# APPLICATION

SEWAGE DISPOSAL TESTING

MARYLAND STATE DEPARTMENT OF HEALTH

PROPERTY OWNER Clarence Bassler

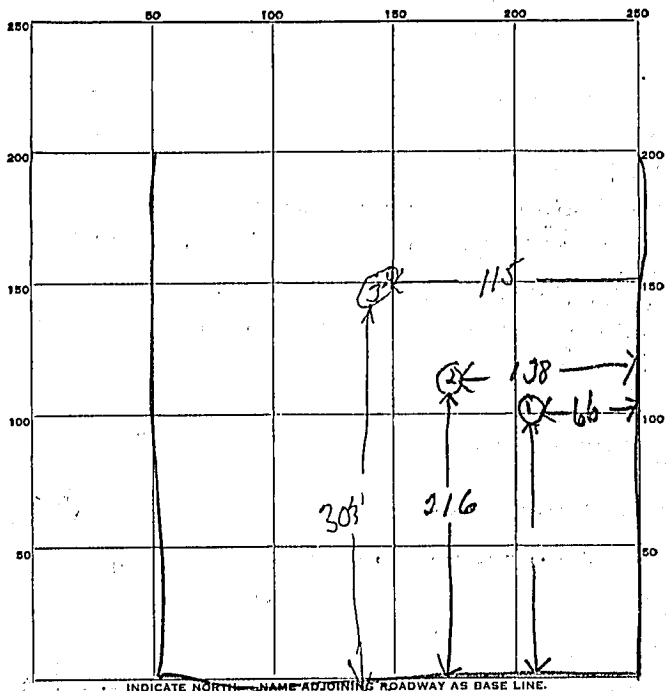
Septic tank - 750 gal  
Dry Well - 300 sq. ft. absorbent sidewall area  
below inlet pipe. Inlet pipe must be 4 ft below  
original ground level  
Locate drywell <sup>30'</sup> ft from front lot line and <sup>115'</sup> ft  
from ~~left~~ right side line as lot is seen facing  
from Day Road
